STAFF REPORT 5-8-2019 MEETING  
APPLICATION NUMBER 19-6181  
ADDRESS: 2081 VERMONT  
HISTORIC DISTRICT: CORKTOWN  
APPLICANT: JIM KORF  
DATE OF STAFF VISIT: 5-2-2019

Re: Building Rehabilitation  
2081 Vermont  
Detroit, Michigan

NORTH ELEVATION  
1/4" = 1'-0"

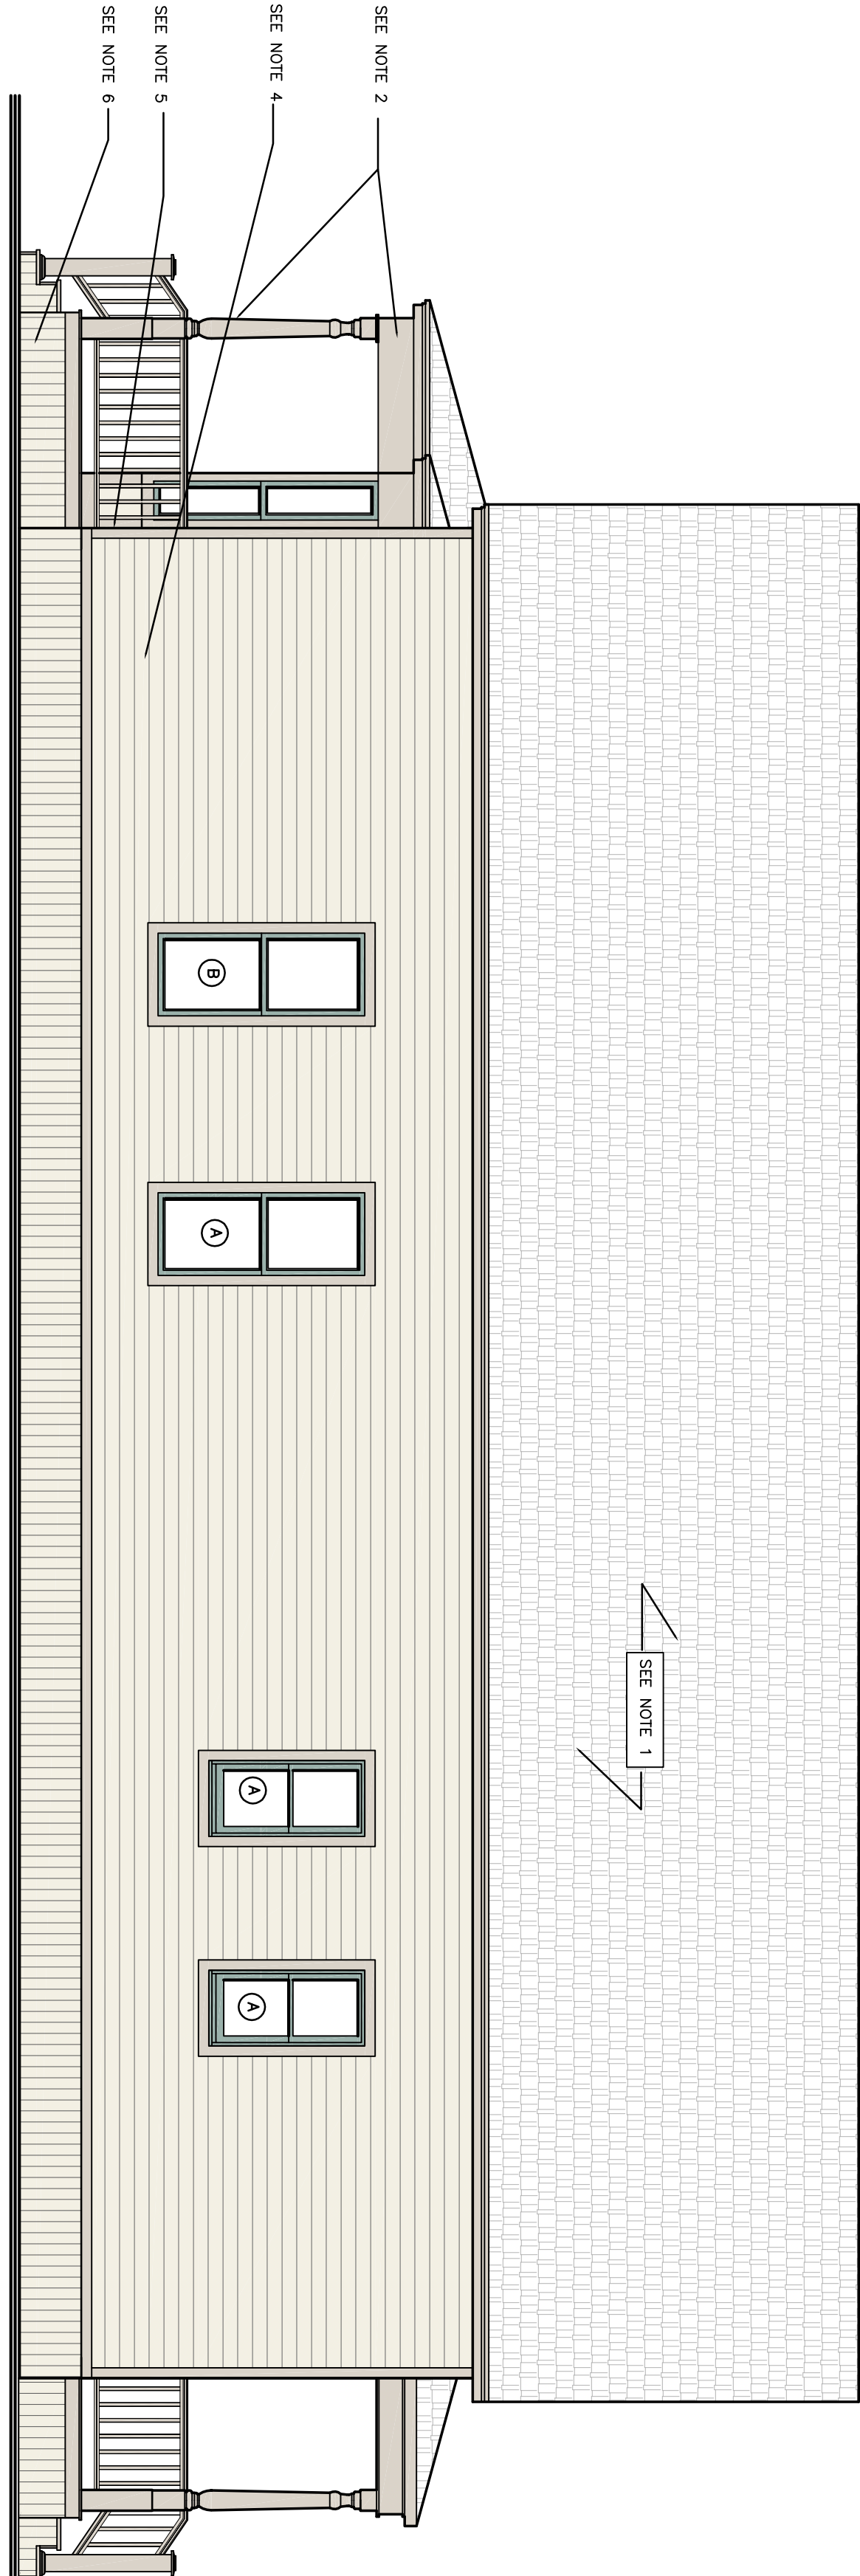
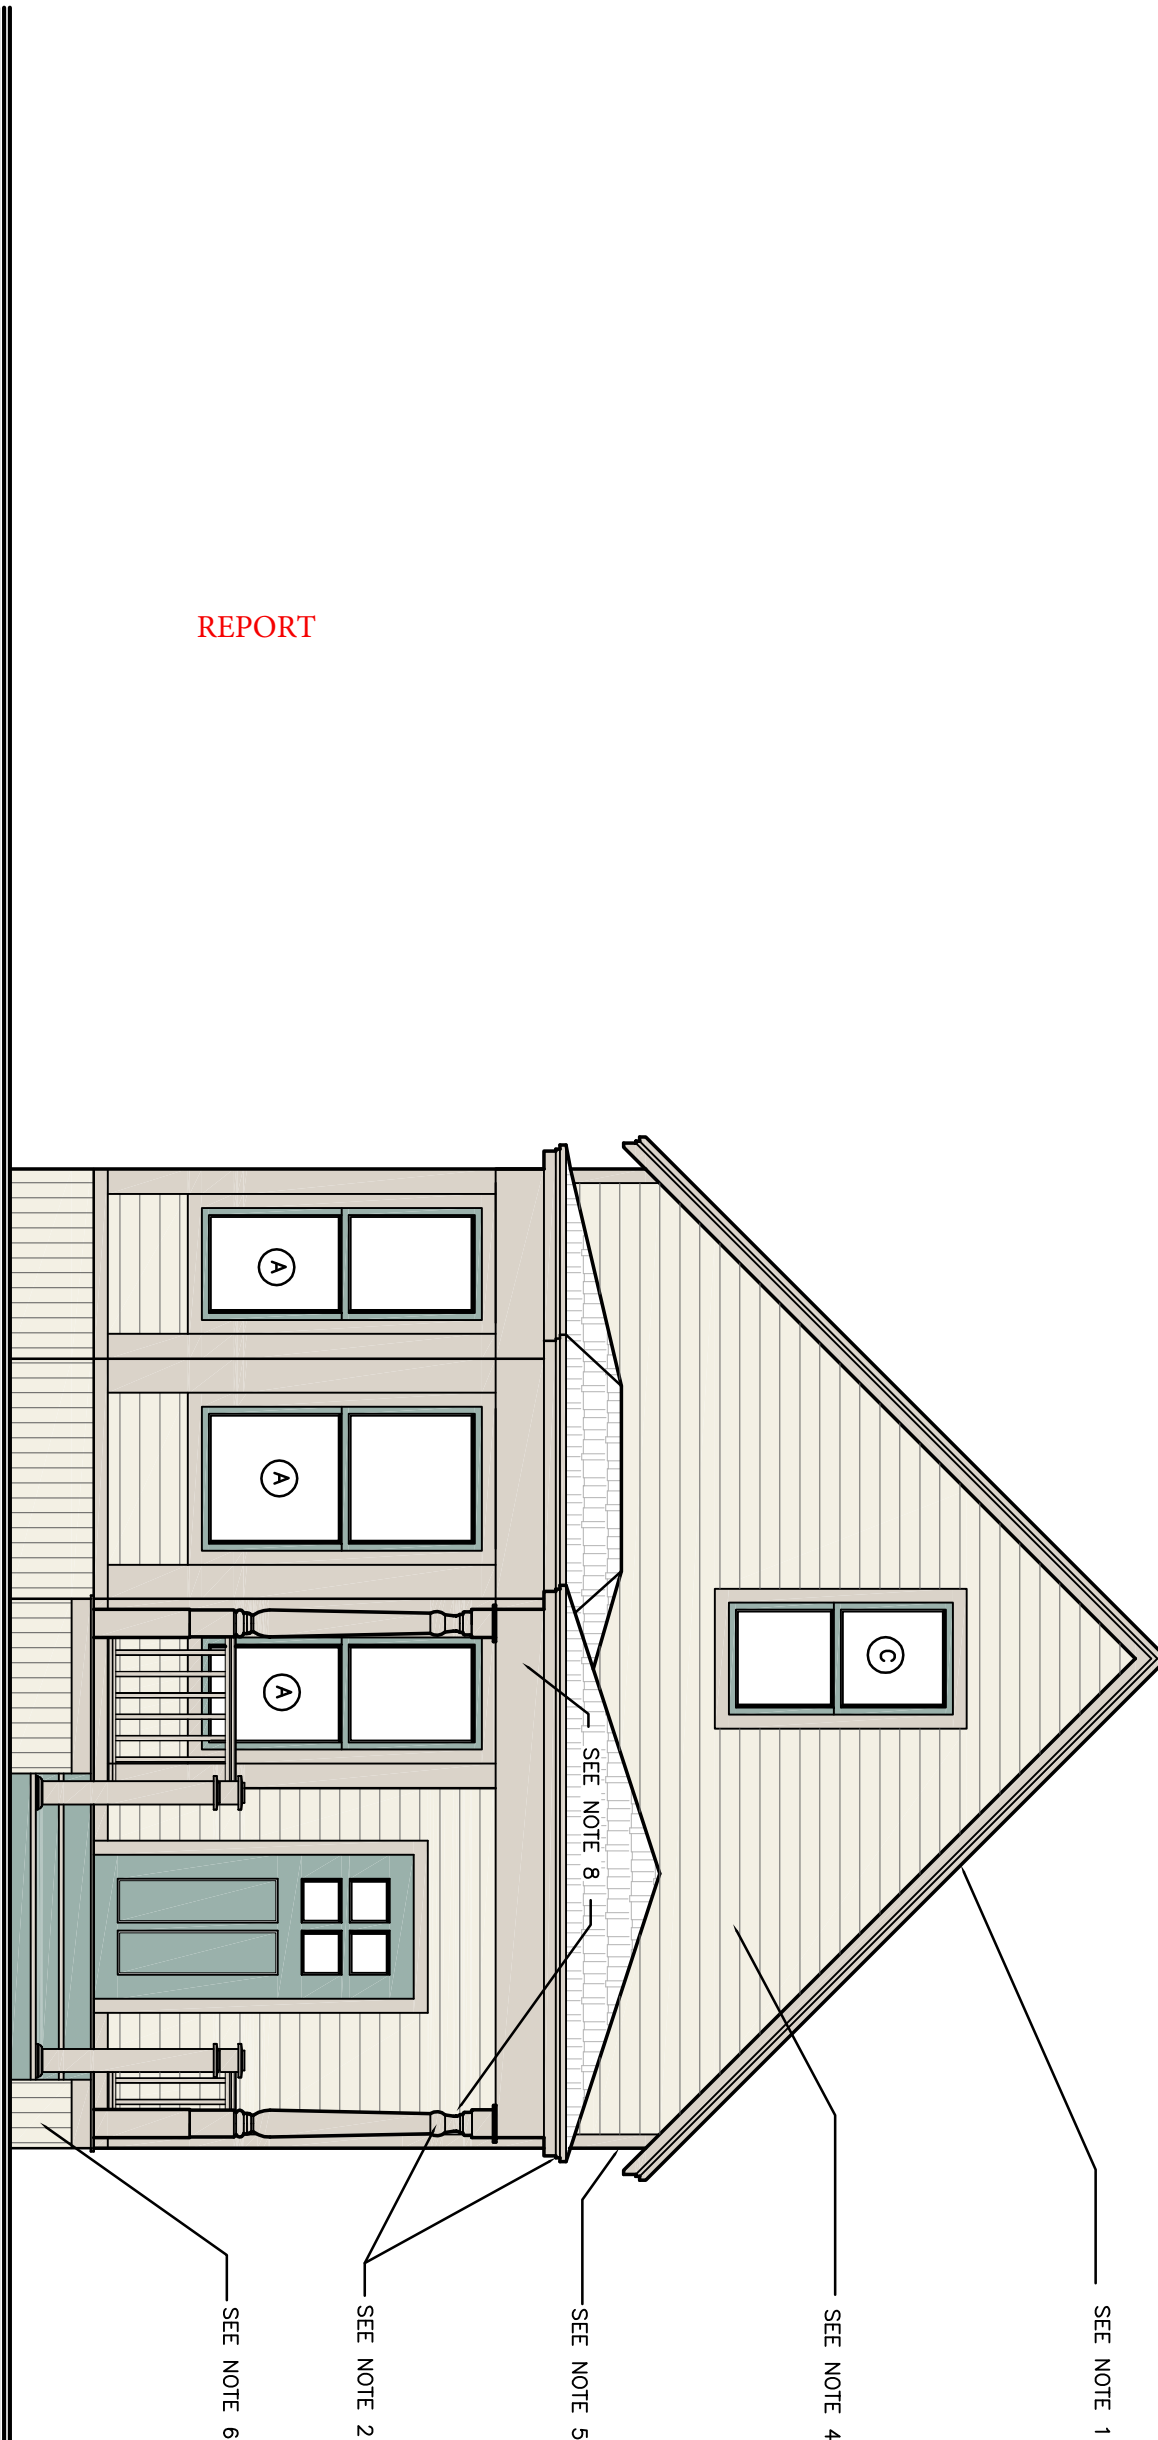
- Install new wood skirting over the existing brick foundation wall
- Replace three existing 2/2 wood windows and trim with new 1/1 wood windows and trim
- Toward the front of the wall, punch in a new window opening and install new 1/1 wood window and wood trim

- The existing front porch roof is flat. The proposed/new front porch roof is hipped
- New wood skirting is proposed to clad the brick at the rear ½ portion of the side elevation foundation walls and the rear foundation will
- The brick chimney is proposed to be removed
- The existing original 2/2 wood windows at the side elevations are proposed to be replaced with new 1/1 wood windows
-

- The new front porch roof shall be flat/shed to replicate the existing
- The existing wood siding, corner trim, and window trim/brickmould at the front and side elevations shall be retained and repaired where necessary with new to match the existing in material, dimension, reveal, and detailing
- The new wood sash at the front and side elevations shall match the existing/those proposed for replacement in light configuration and operation
- The existing brick chimney must be retained or replicated (if replacement is necessary)
- The existing roof height and pitch shall be maintained
